**Before the  
FEDERAL COMMUNICATIONS COMMISSION  
Washington, DC 20554**

In the Matter of	)	
	)	
Viasat, Inc.	)	File No. SES-LIC-20200811-00852
	)	Call Sign E202143
Application for Blanket Earth Station License	)	
Using Ka-band Spectrum	)	
	)	
	)

**COMMENTS OF VERIZON<sup>1</sup>**

**Figure 1: Impact of Section 25.202(f) OOB Limits in 27.5-28.35 GHz Band Assuming Adjacent 250 MHz Channel**<sup>9</sup>

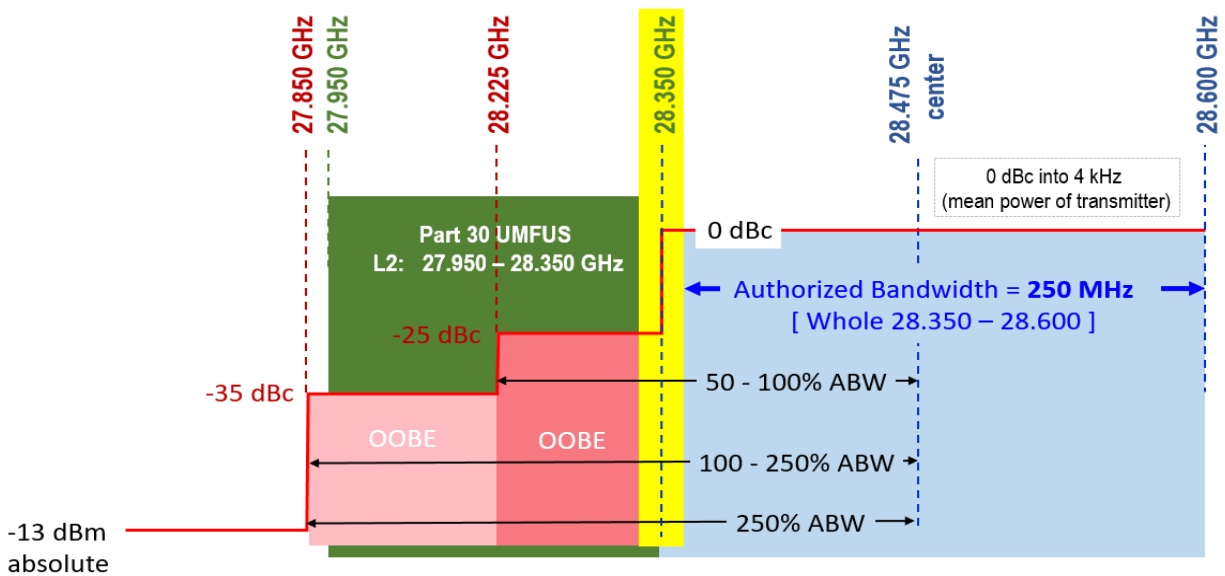
space-based victim NGSO satellite receivers from FSS earth station transmitter interference have the advantage of great distance. By contrast, the victim terrestrial UMFUS receiver may be much closer to the FSS earth station transmitter. Figure 1 below illustrates the impact to UMFUS licensees of the existing Part 25 OOB limits.

As this figure demonstrates, the permitted Part 25 OOB spillover encompasses the entire Part 30 L2 allocation.

Based on the information that Viasat has provided, OOB from Viasat’s 1.8 meter fixed earth stations operating within 3.23 kilometers of Verizon’s 5G 28 GHz network could significantly degrade Verizon’s 5G network depending on how Viasat’s and Verizon’s antennas

response to a satellite operator’s technical submissions.<sup>13</sup> Verizon thus requests that the Commission require Viasat to supplement its Application with additional information regarding its expected deployments, including locations, areas, and densities, and relevant technical details, such as proposed antenna location under Section 101.103(d). This will enable potentially affected terrestrial licensees like Verizon to determine whether additional conditions on Viasat’s license may be necessary to protect UMFUS operations in the adjacent 27.5-28.35 GHz band, such as a requirement that Viasat’s earth stations authorized to operate at or near 28.35 GHz coordinate with UMFUS operators as outlined in Section 25.136(a)(4)(iv).
